# Reference Fuel Design

## SVEA-96 Optima3

**WCAP-17769-NP-A**  
**Revision 0**

**SUBJECT: FINAL SAFETY EVALUATION FOR WESTINGHOUSE ELECTRIC COMPANY  
TOPICAL REPORT WCAP-17769-P/NP, REVISION 0, "REFERENCE FUEL  
DESIGN SVEA-96 OPTIMA3" (EPID L-2014-TOP-0003)**

**Figure 4.3.3-1 Stress Distribution through Cladding at Moment Collapse**

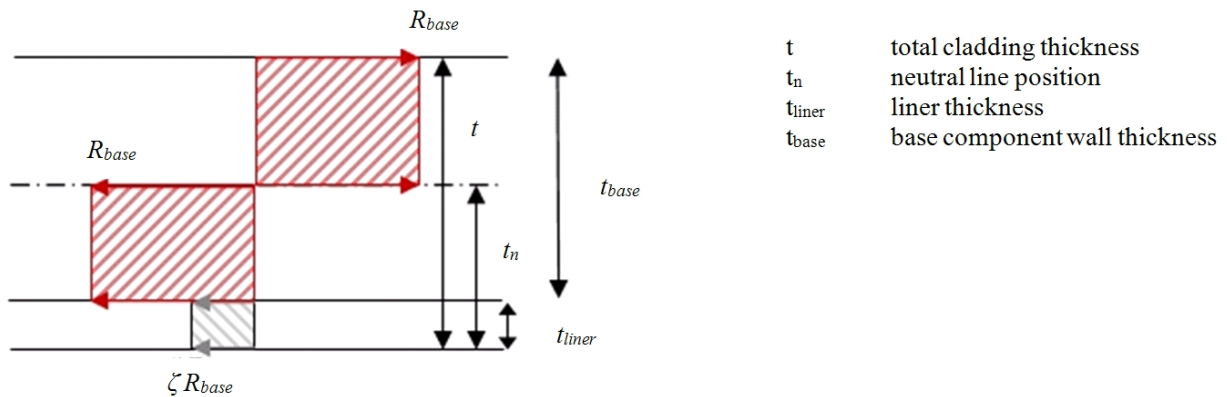
Due to the change in methodology, RAI-06 requested additional details of the ANSYS model. Additionally, clarification of Table 4.3.3-1 (of the TR) was requested. Westinghouse responded by providing a review of the ANSYS models during an audit conducted on May 19-20, 2016 (Ref. 5). Westinghouse updated Table 4.3.3-1 and clarified that the values in Table 4.3.3-1

[ ] In a supplemental response, Westinghouse further clarified that these [ ] Westinghouse provided additional details regarding the stress analyses, which are described in greater detail in Section 3.2 of this SE. Among the details discussed during the audit was that the Level B collapse load limit was [ ] described in ASME Boiler and Pressure Vessel Code 2010, Section III Subsection NB. As discussed in Section 3 of this SE, this was not a safety concern.
